File No.: ZDO-270: TSP Minor Amendments

Land Use Hearing Item Staff Report to the Board of County Commissioners

File Number: ZDO-270, Updates to Figures, Maps and Tables for Comprehensive Plan Chapter 5, Transportation System Plan

RE: ZDO-270: Updates to Figures, Maps and Tables for Comprehensive Plan Chapter 5
Transportation System Plan

Figure 5 - 1a
 Typical Urban Major Arterial Cross Section

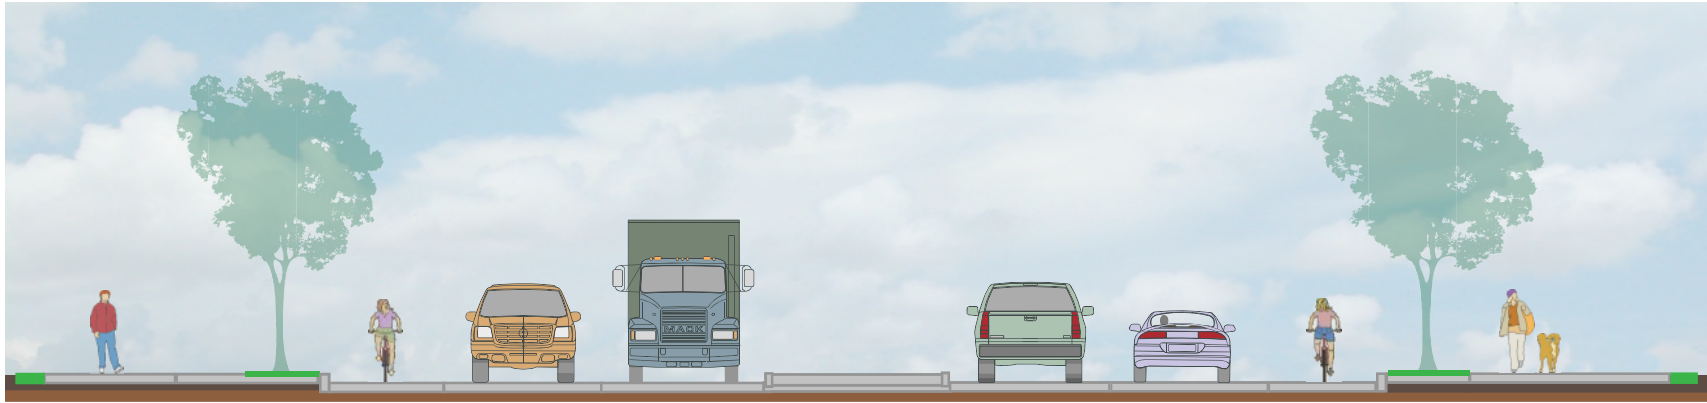
- Figure 5-1a, Typical Urban Major Arterial Cross Section
 - Bikeway width was increased to 8'. The national standard for a bikeway on a major arterial is 8' due to the high traffic volume and that width is identified as the Clackamas County standard in the Clackamas County Active Transportation Plan.
 - Landscape strip and curb has been widened to 5'6" to accommodate a 5' landscape strip and 6" curb.

- Pedestrian facility width varies between 6' and 8' based on the type of pedestrian facility as called for in the Active Transportation Plan.
- Figure 5-1b, Typical Urban Minor Arterial Cross Section

Figure 5 - 1b
 Typical Urban Minor Arterial Cross Section

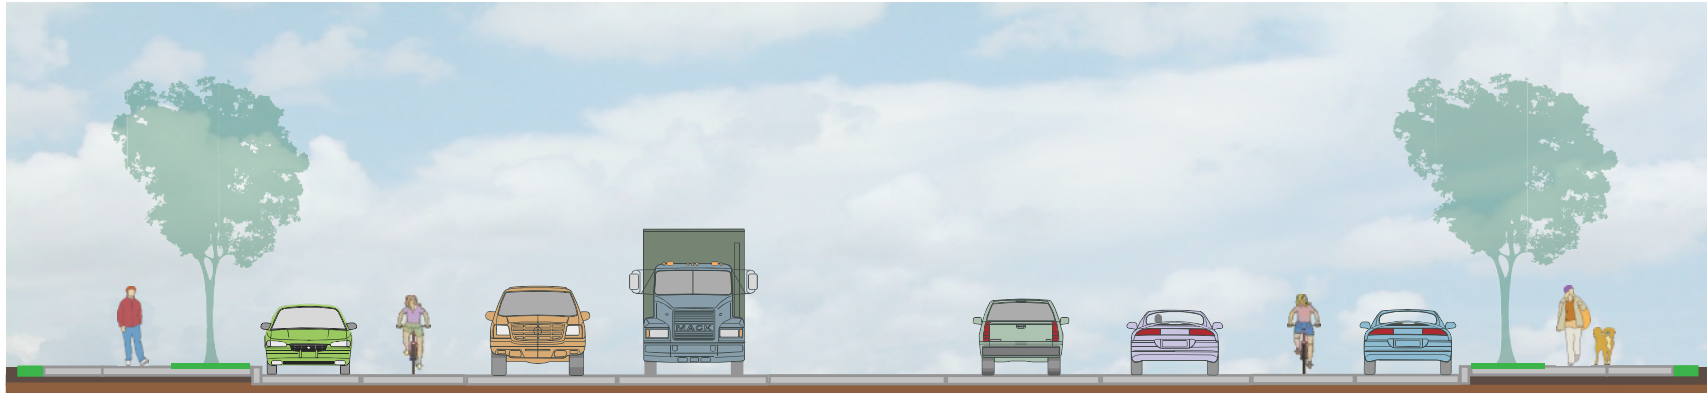
- Parking lane width of 7'-8' is proposed to be allowed to provide consistency with Clackamas County Roadway Standards.
 - Landscape strip and curb has been widened to 5'6" to accommodate a 5' landscape strip and 6" curb.

Figure 5 - 1c
 Typical Urban Collector Cross Section

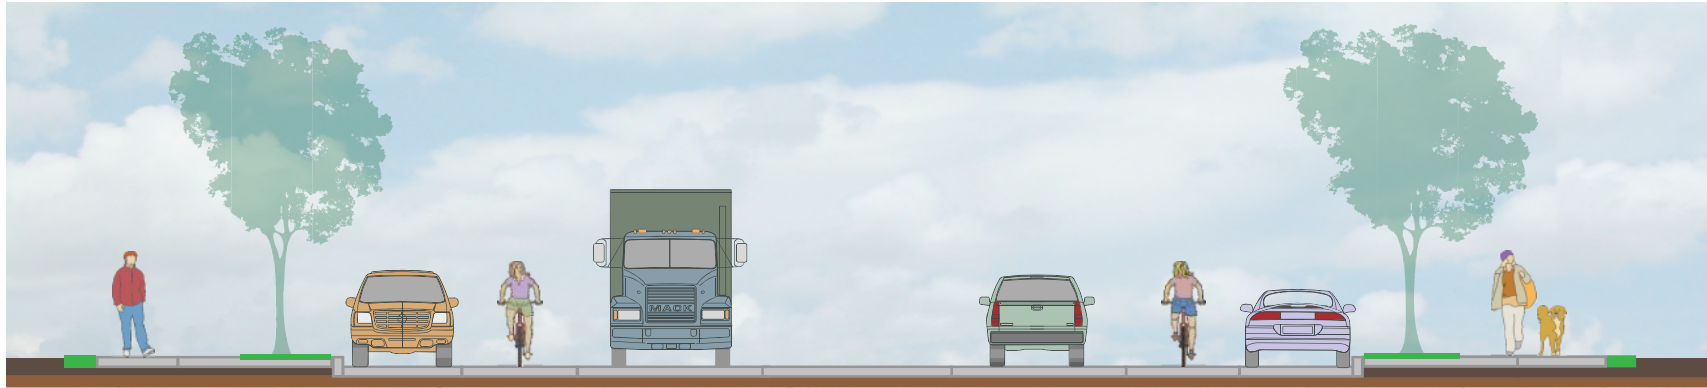
- Figure 5-1c, Typical Urban Collector Cross Section
 - Left turn lane/median re-designated from "optional" to "as needed" to be consistent with Clackamas County Roadway Standards.

- Parking lane width of 7'-8' is proposed to be allowed to provide consistency with Clackamas County Roadway Standards.
 - Landscape strip and curb has been widened to 5'6" to accommodate a 5' landscape strip and 6" curb.

Figure 5 - 1de
 Typical Urban Connector/Local Cross Section

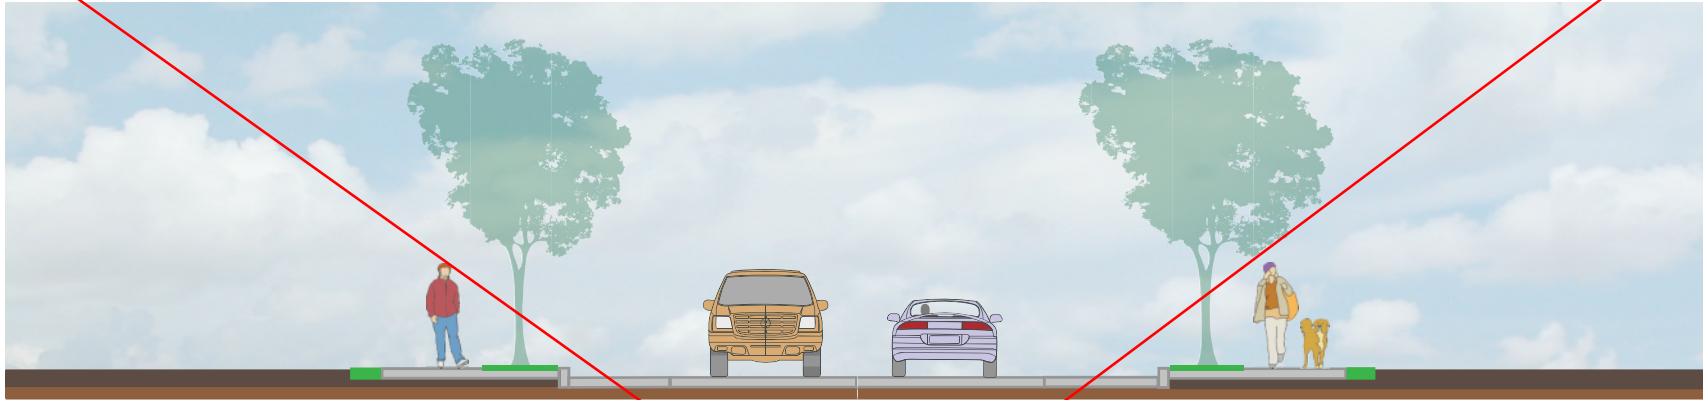
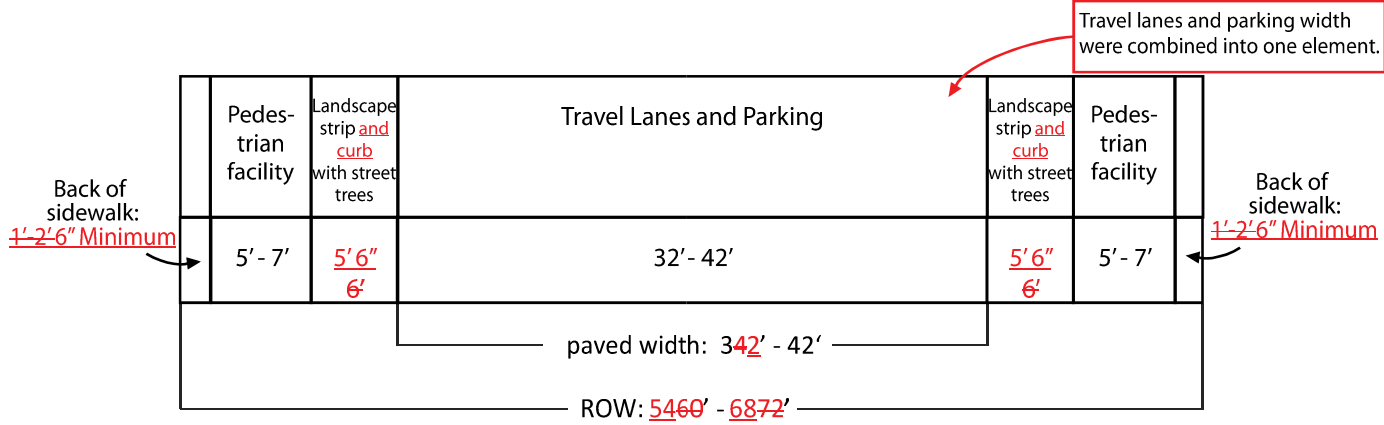
- Figure 5-1d, Typical Urban Connector/Local Cross Section – The Urban Connector Cross Section (previously Figure 5-1d) is the same as the Urban Local Cross Section (previously Figure 5-1e), so those have been combined in one cross section, and re-titled "Figure 5-1d, Typical Urban Connector/Local Cross Section".

Combine these 2 cross sections

Figure 5 - 2a
 Typical Rural Arterial Cross Section

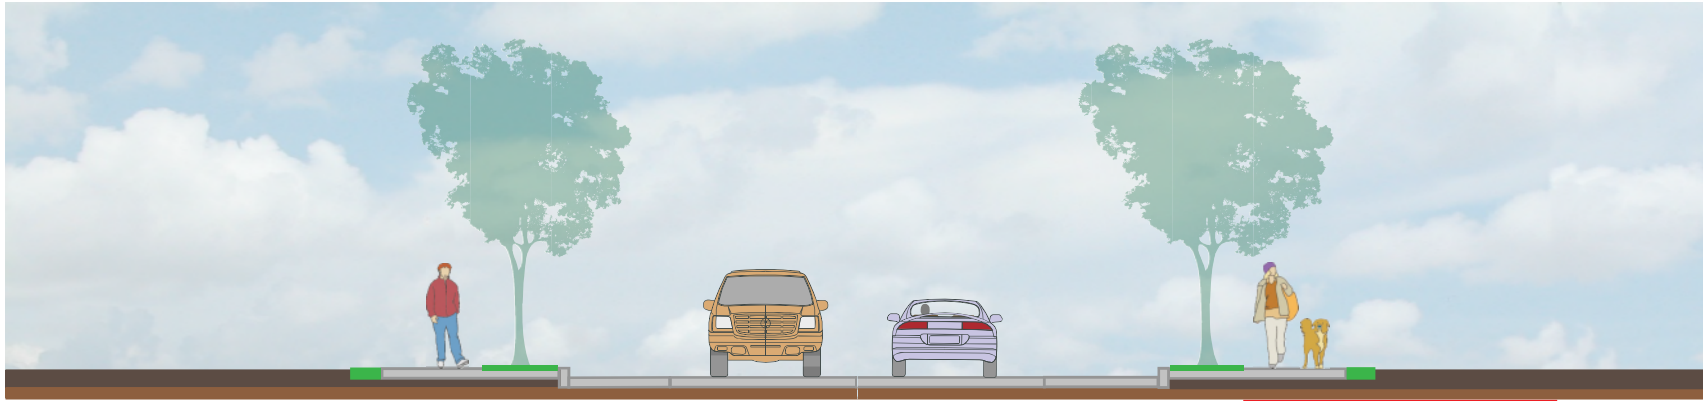
- Figure 5-2a, Typical Rural Arterial Cross Section
 - Left turn lane/median has been re-designated from "optional" to "as needed" to be consistent with Clackamas County Roadway Standards.

Figure 5 - 2b
 Typical Rural Arterial Cross Section
 Unincorporated Communities

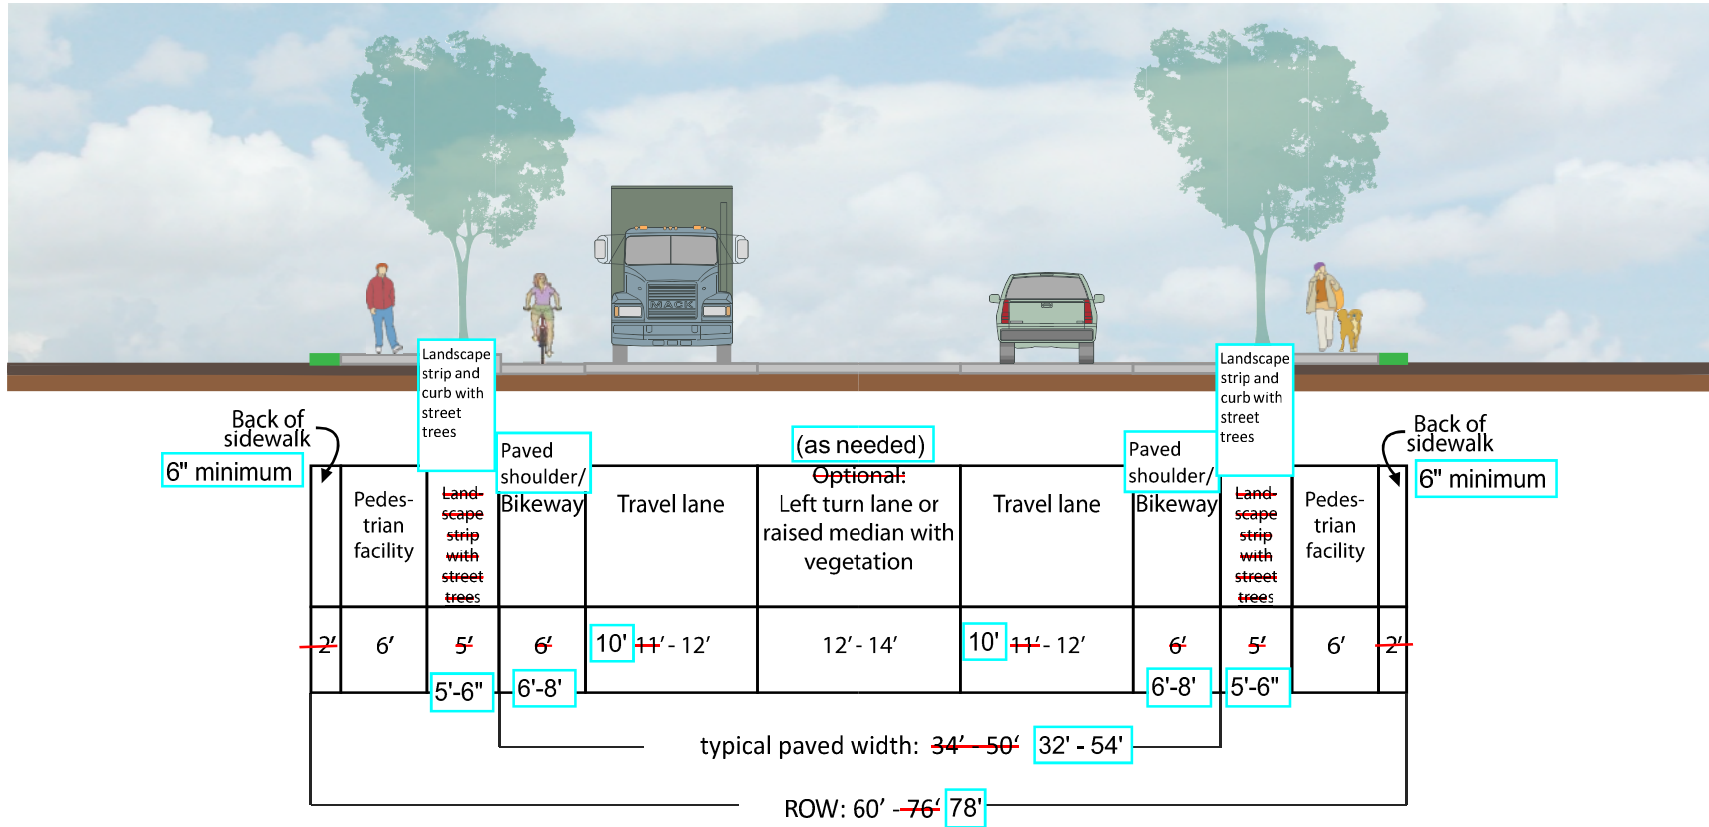
- Figure 5-2b, Typical Rural Arterial Cross Section Unincorporated Communities
 - Left turn lane/median has been re-designated from "optional" to "as needed" to be consistent with Clackamas County Roadway Standards.

- Paved shoulder/bikeway width has been revised to conform to national standards and the provisions of the Active Transportation Plan.
 - Landscape strip and curb has been widened to 5'6" to accommodate a 5' landscape strip and 6" curb.

Figure 5 - 2c
 Typical Rural Collector Cross Section

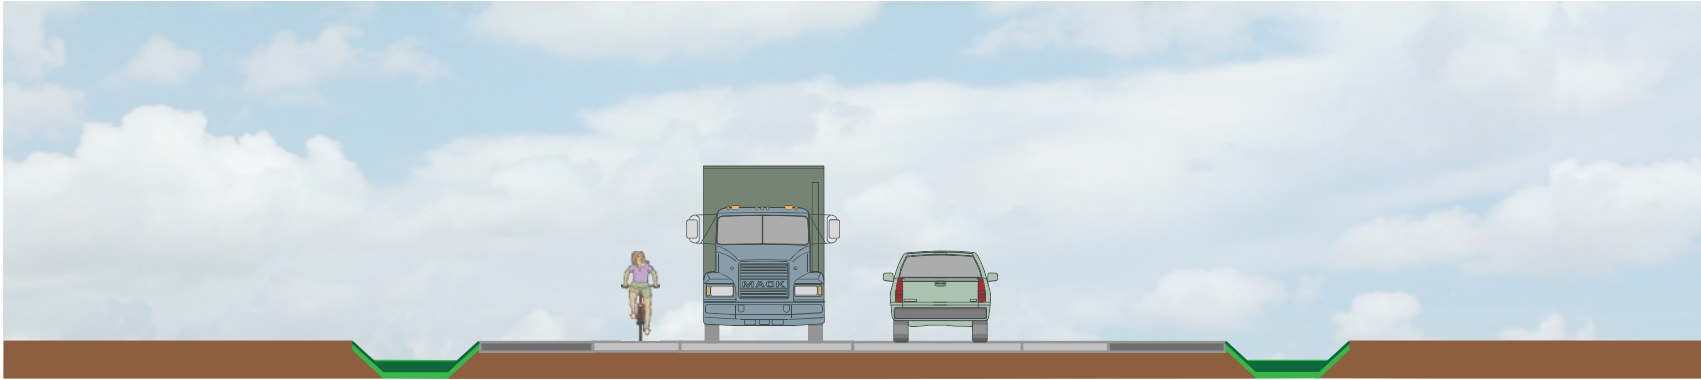
- Figure 5-2c, Typical Rural Collector Cross Section
 - Paved shoulder bikeway has been revised to "Paved shoulder/bikeway" to be consistent with the Active Transportation Plan.

Figure 5 - 2d Typical Rural Collector Cross Section Unincorporated Communities

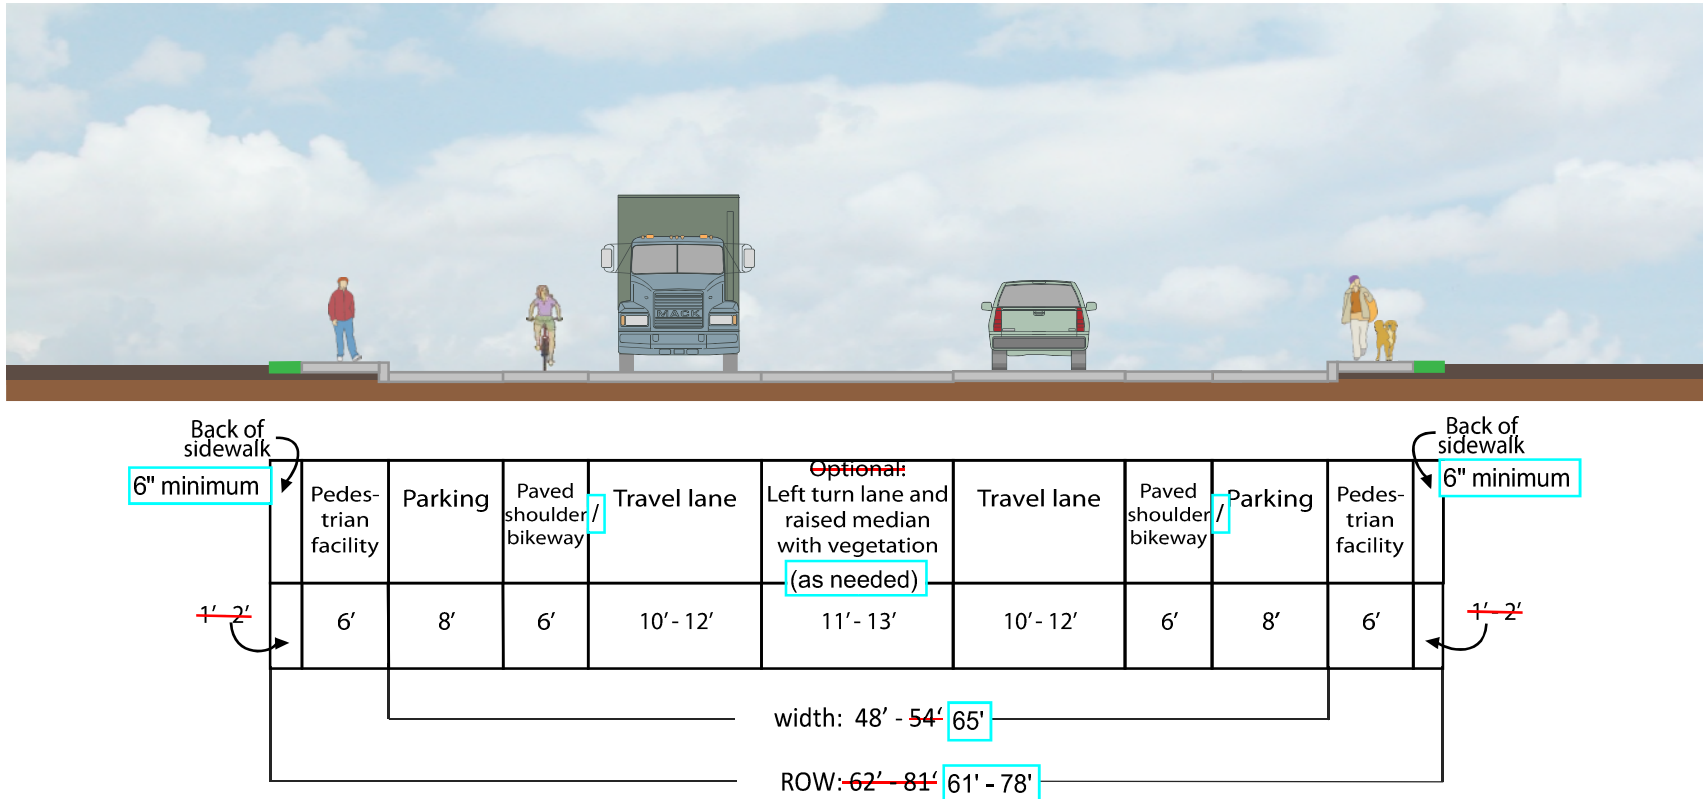
- Figure 5-2d, Typical Rural Collector Cross Section Unincorporated Communities
 - Left turn lane/median has been re-designated from “optional” to “as needed” to be consistent with Clackamas County Roadway Standards.

- Paved shoulder bikeway has been revised to “Paved shoulder/bikeway” to be consistent with the Active Transportation Plan and with other cross sections.

Figure 5 - 2ef
 Typical Rural Connector/Local Cross Section

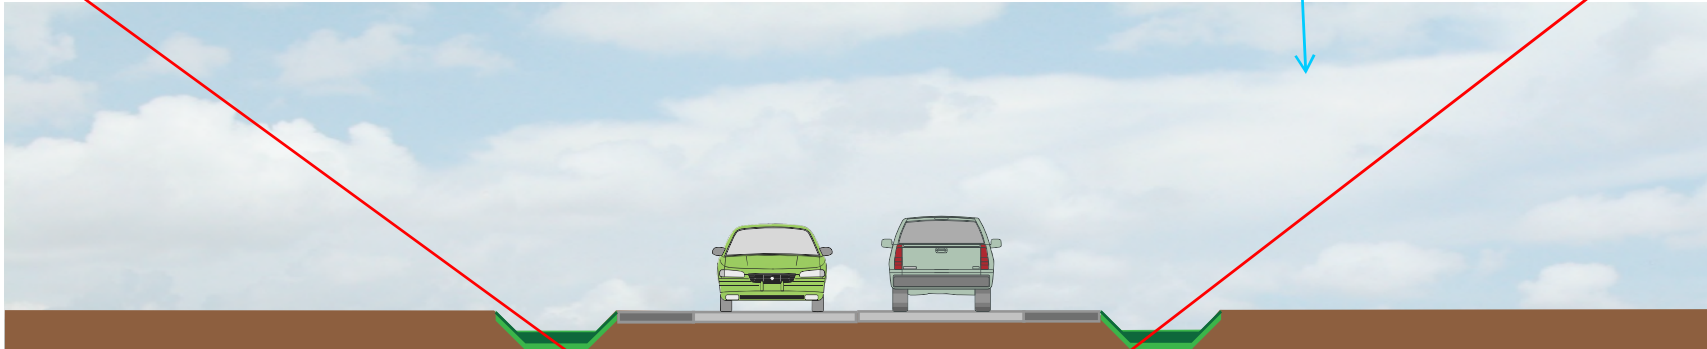
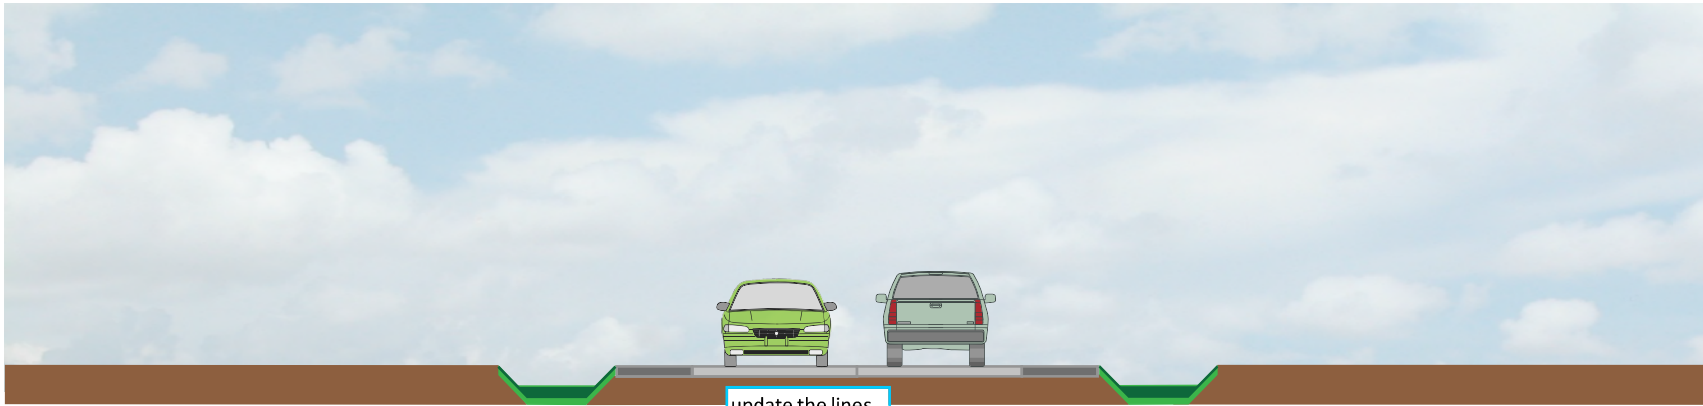
- Figure 5-2e, Typical Rural Urban Connector Cross Section – The Rural Connector Cross Section is the same as the Local Cross Section, so those have been combined in Figure 5-2e.

- Figure 5-2f, Typical Rural Connector/Local Cross Section
 - Paved width was incorrectly shown in the adopted version to include the gravel shoulders. In the proposed revised diagram “paved width” only applies to the paved section of the road and does not include the gravel shoulder width. This change simply corrects a previous mistake and neither the travel lane width nor the gravel shoulder width are proposed to change.

Combine these 2 cross sections
